COMMITTEE OF THE WHOLE (PUBLIC MEETING) – MARCH 2, 2021

COMMUNICATIONS

Re: Letter of Concern
2232394 Ontario Inc. - Notice of Meeting
OP.20.010 & Z.20.31

Figure 23 – Shadow Study- March/September (source: Architectural drawings, pp. 32)

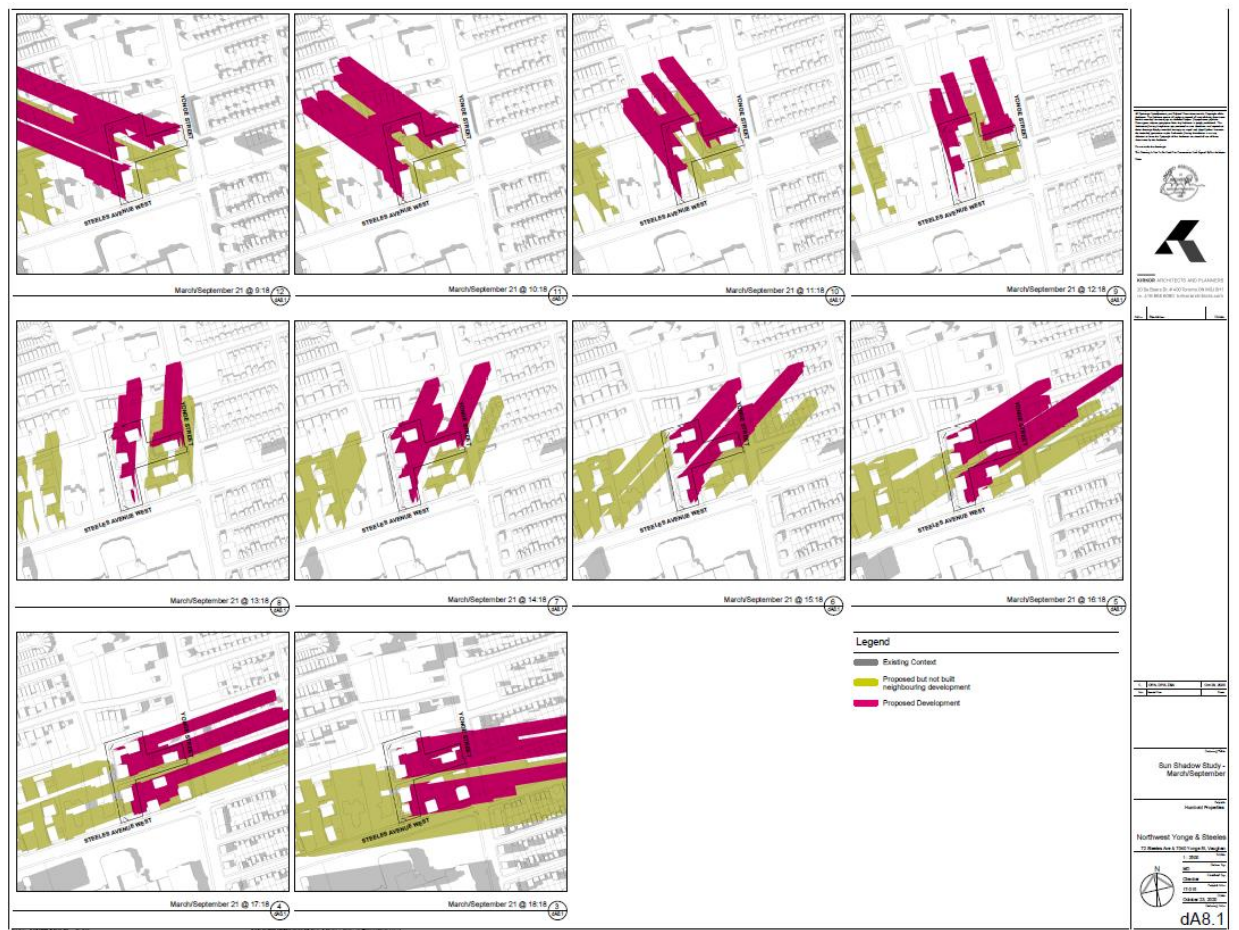
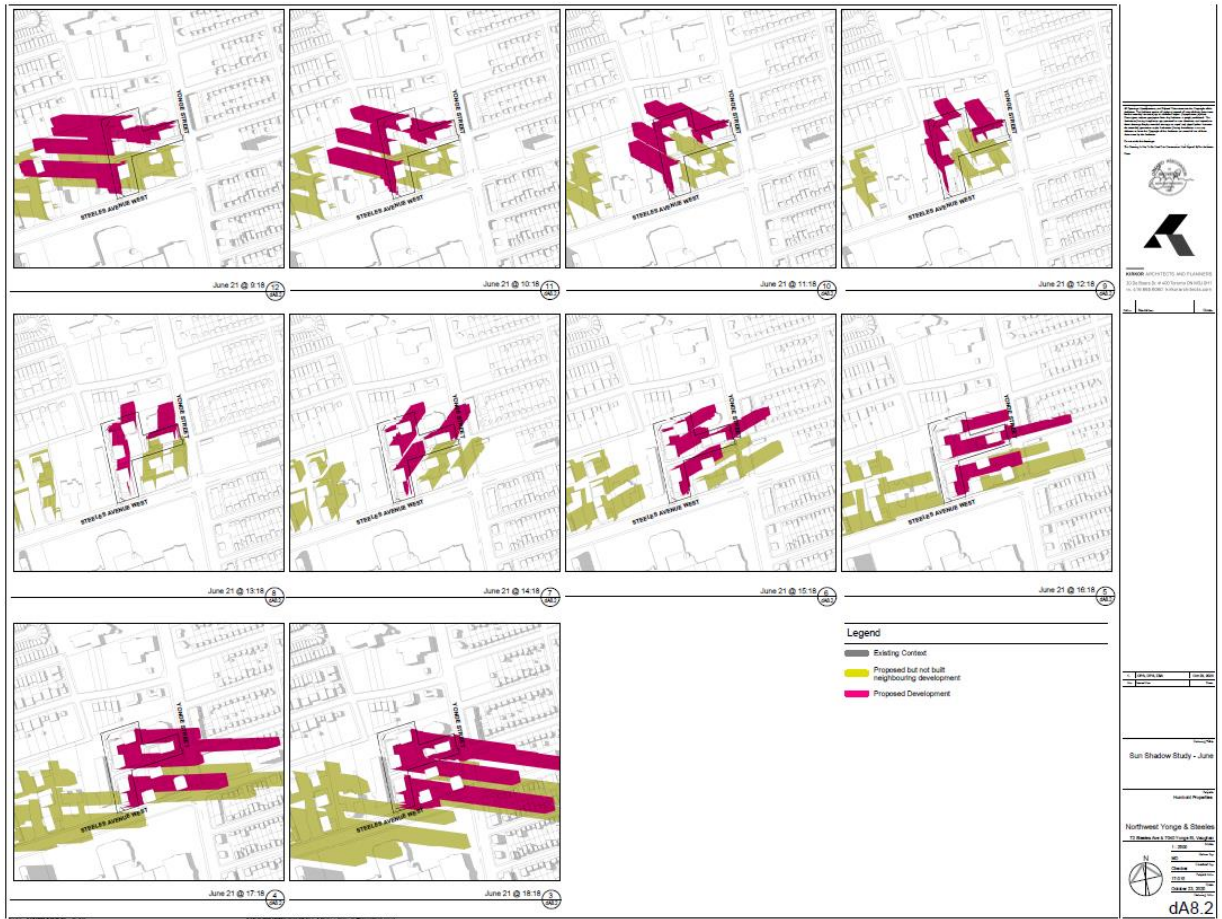
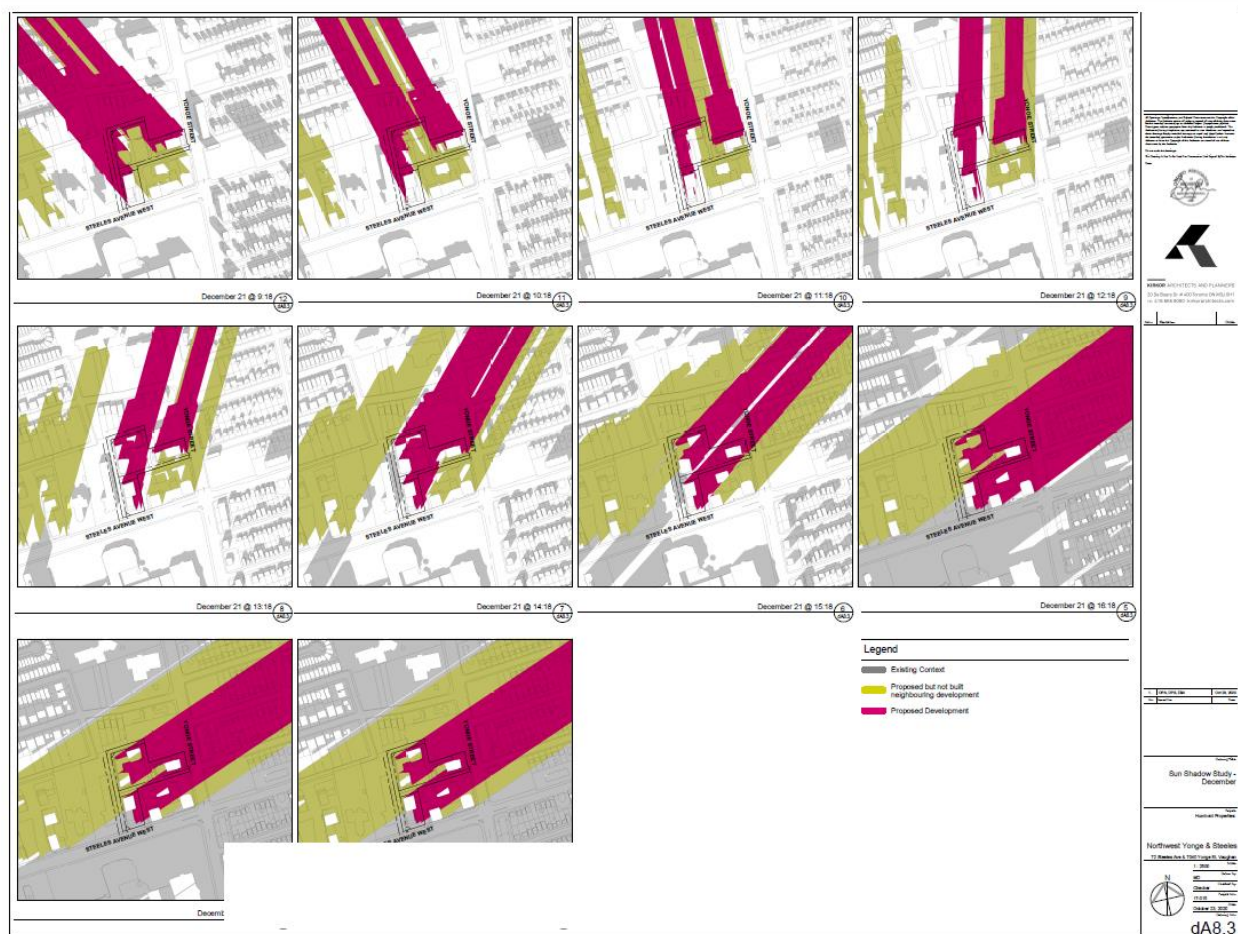
Shadows accrue from building height, massing and siting. The shadow study included in the Urban Design Brief (p. 59) shows (see Figures 23, 24, and 25) the Humboldt buildings' shadows in red, and the other buildings in the area (Gupta and Salz) in green. We note that the much-vaunted green space in the center of the proposal will be shaded for 23 of 24 hours of the day for much of the year, due to shadowing from Building 1 as well as the three proposed Gupta towers. This demonstrates a lack of integration and co-ordination between the Gupta and Humboldt projects, which will need to be resolved. Significant shadowing across the eastern side of Yonge Street in Markham must also be addressed. The simplest solution is to reduce building heights and the number of buildings.
